SUMMARY OF CONCERNS IN RELATION TO THE PROPOSED NORTHCONNEX TUNNEL

This is an objection to many aspects of the proposed NorthConnex tunnel.

Figure 5-17 Motorway operations complex

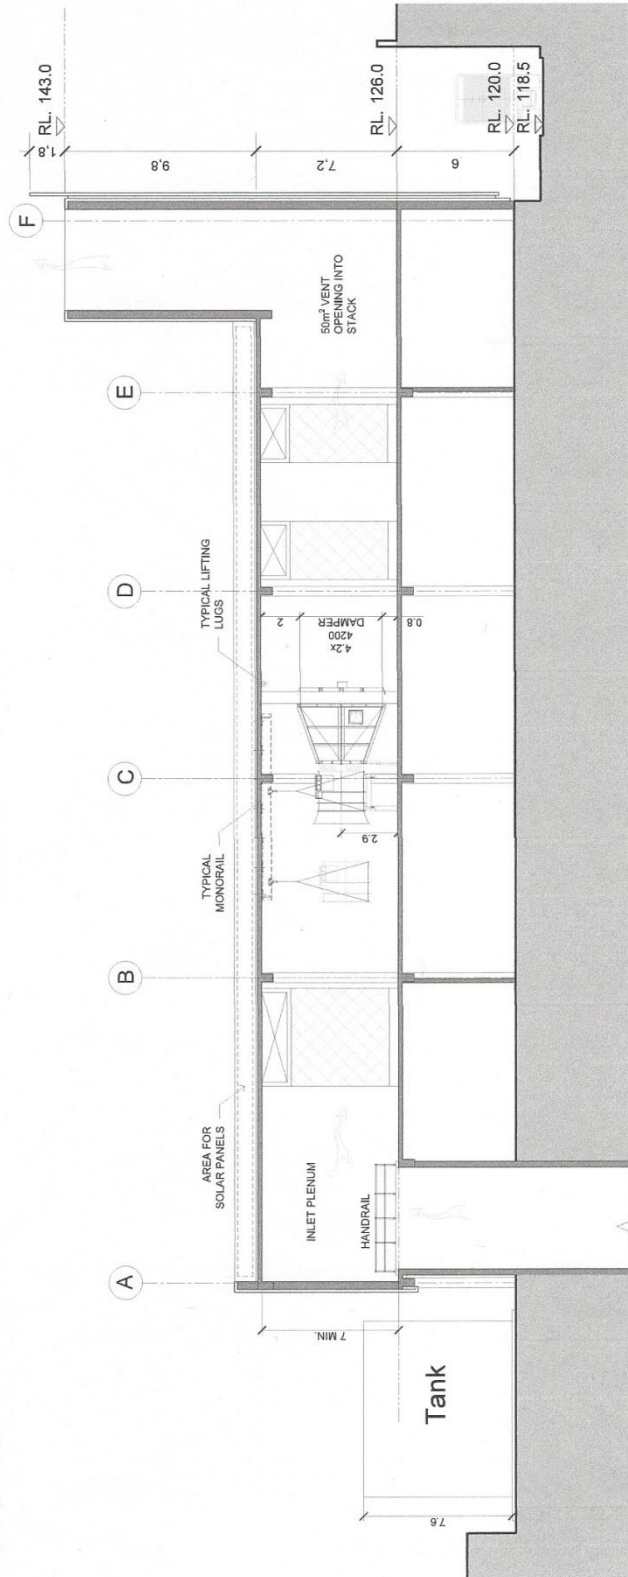
EIS Page 111, *Figure 5-17 Motorway operations complex*

Page 8 below there is no indication of how the ventilation facility will be connected to either the northbound or southbound tunnel, nor is there any indication of how the southbound exit portal onto Pennant Hills Road or the south-west exit portal onto the M2 will be connected.

- Diagrams need to be provided showing the inter-relation between the shaft, the ventilation outlet and the motorway operations centre with a clear description of what is to be constructed and how it will operate.
- The community needs irrefutable evidence that the polluted air from the southbound tunnel exit portals will not be allowed to flow like an invisible sewer through West Pennant Hills, North Rocks, Carlingford and Beecroft.

MOTORWAY OPERATIONS COMPLEX - SOUTHERN VENTILATION FACILITY - SECTIONS
M1-M2-5000-DR-JD-0525

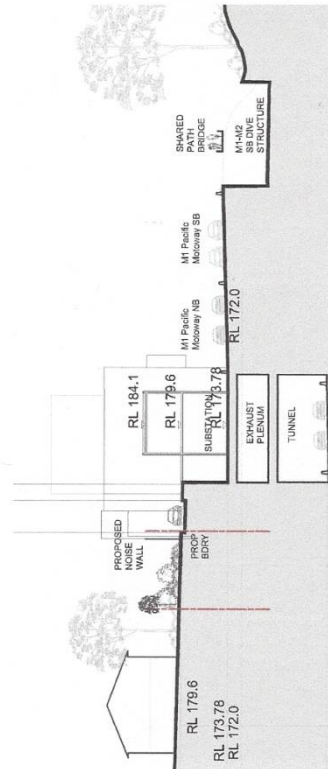
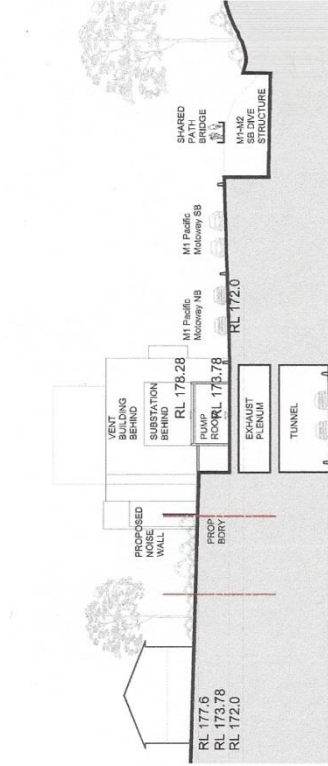
5. *EIS Volume 4, Technical working papers - Urban Design, 6.0 Operational Ancillary Facilities*
EIS Page 99 there is the diagram "Motorway Operations Complex – Southern Ventilation Facility – sections. *Page 10 below* The diagram has the cryptic label "Connection to tunnel TBC". What does TBC stand for? To be considered? Why is tunnel singular? Which tunnel is the diagram referring to northbound or southbound? There is no diagram showing any connection from the Southern Interchange ventilation facility to either the northbound or the southbound tunnel in any way AND YET

MOTORWAY OPERATIONS COMPLEX - SOUTHERN VENTILATION FACILITY - SITE SECTION 1-1
M1-M2-5000-DR-UD-0713

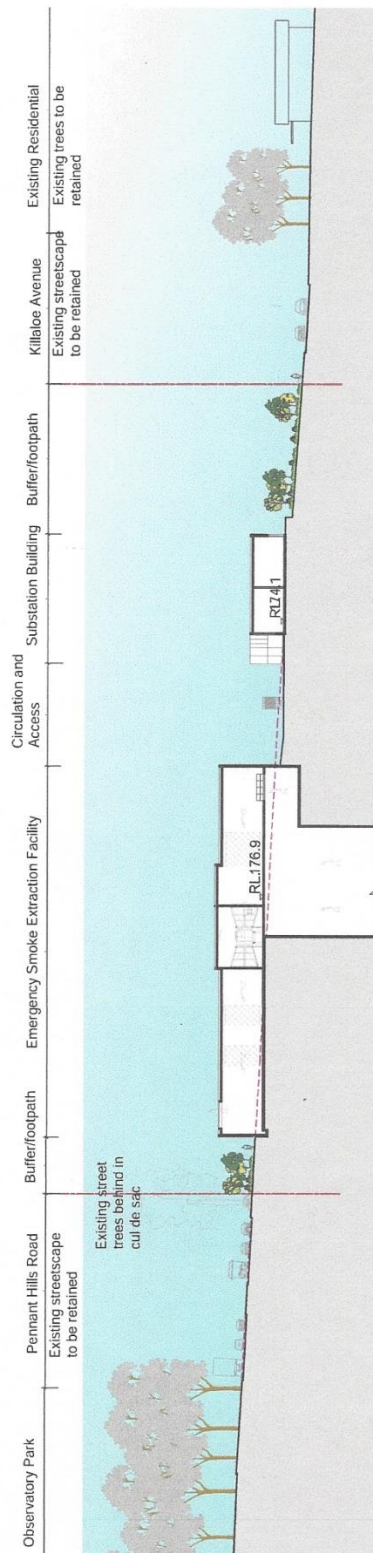
6. *EIS Volume 4, Technical working papers Urban Design, 8.0 Landscape Design*
EIS Page 176 is the diagram "Motorway Operations Complex – Southern Ventilation Facility – Site 1-1". *Page 13 below* The diagram does not show any connection to either the northbound or southbound tunnel. In the same Landscape Design section, EIS Page 182 is the diagram "Wilson Road Tunnel Support Facility –Section" *Page 14 below* which clearly shows the connection to the tunnels. In the same Landscape Design section, EIS Page 189 is the diagram "Northern Ventilation Facility – Landscape Concept Section". *Page 15 below* This also clearly shows the connection to the tunnels.
